Access Compliance Report

Public Rights-of-Way

(Pedestrian Signals)

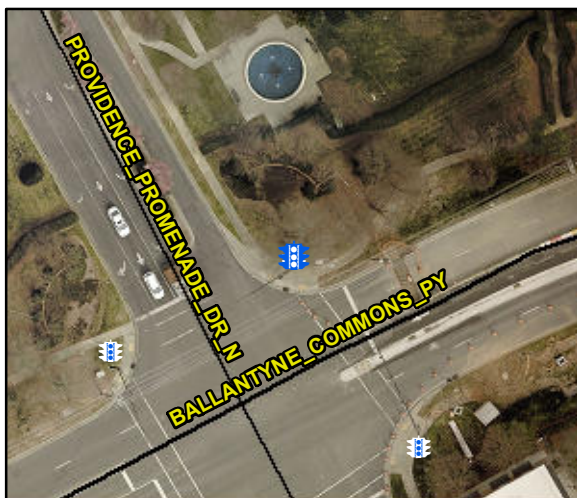
Intersection ID: N/A	Main Street:	Cross Street: N/A	Location: N/A
ADA ID: 3CA83EC2118F	Signal Type: Two Push Buttons-Non APS	Overall Compliance: No	Severity Score: BTN 1:N/A BTN 2: N/A No BTN: N/A
Codes/Mitigation Info/Possible Solution		Field Measurements/Component Compliance

PROW/ADA: TMUTCD 4e.08, R404.2, R404.3, R406.2

Possible Solutions: Replace Signal Push Button With APS Button on New Post. Remove & Relocate Sign.
